To: Docketing Division
From: George Martin, Grade Crossing Planner, Rail Division
Re: In the matter of the authorization of the Cleveland Commercial Railroad to install an active grade crossing warning device in Cuyahoga County
Date: June 29, 2016

TO: Randall Schumacher, Supervisor, Rail Division, PUCO
FROM: Cathy Stout, Manager, Safety Section, ORDC
BY: James Tucker, Project Manager, ORDC J.T.
SUBJECT: Cuyahoga County, SR 175/Richmond Rd DOT#262449A
DATE: June 28, 2016

RE: Cuyahoga County, SR 175, Richmond Rd, DOT#262449A, PID# 101963.

DOT 262449A (SR175) SH-2069

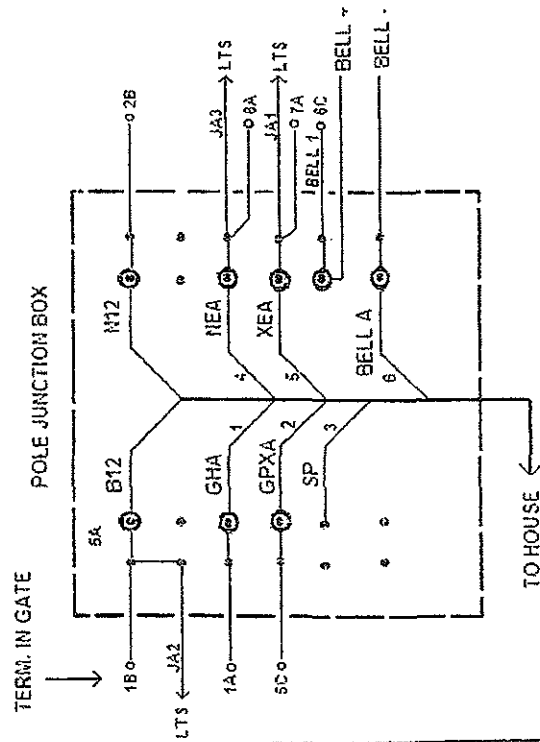
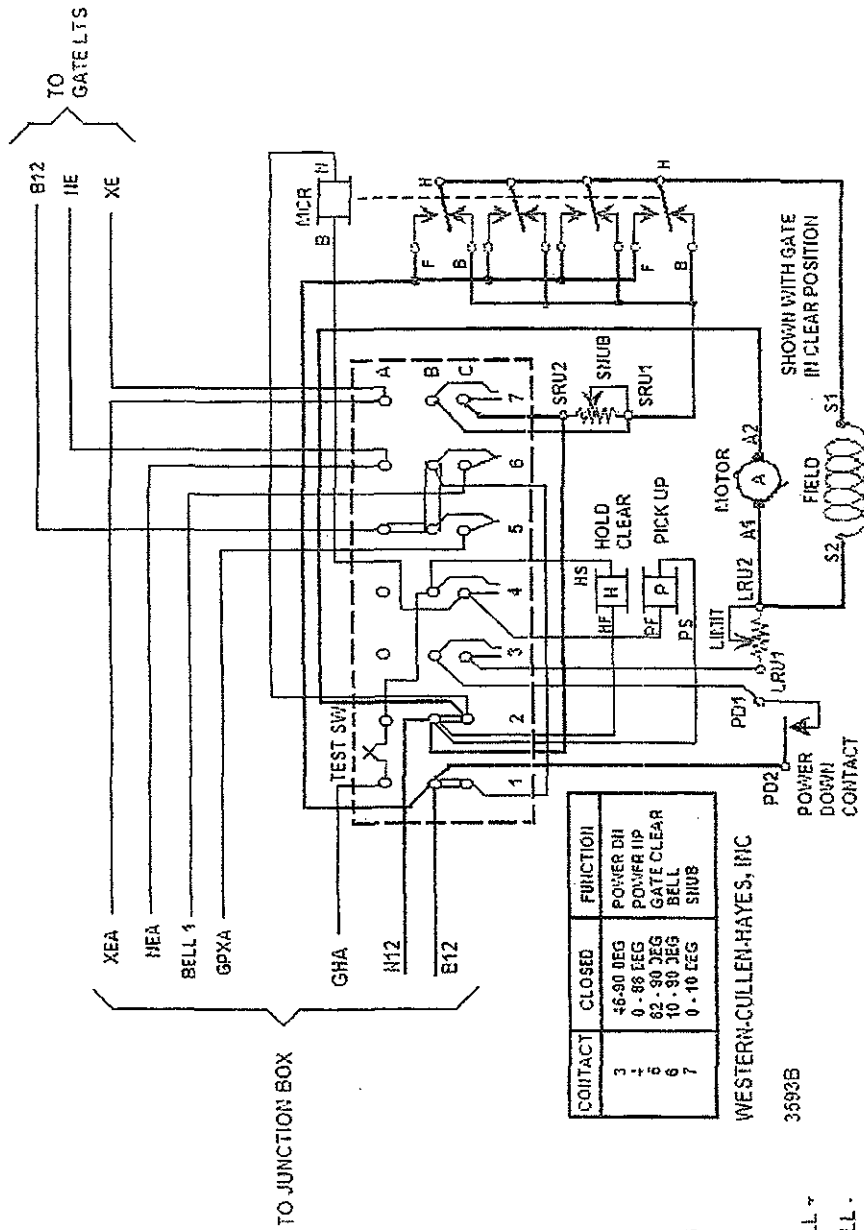
The submitted plans for Richmond Rd have been reviewed and the site layout is acceptable. Our engineer has concerns with the approach distances. Currently you show the start lengths at 150', that only provides 20 seconds of warning time for trains approaching at 5 MPH. The Diagnostic shows the authorized train speeds are 10 MPH. With that said, the approach starts would need to be adjusted to meet the 10 MPH speeds or restrict the speeds of the approaching trains to 5 MPH. Please provide me with an update so I can get construction authorized.

Wally,
Please revise the plans to allow for a 10 mph approach start.
Thanks,
Mike
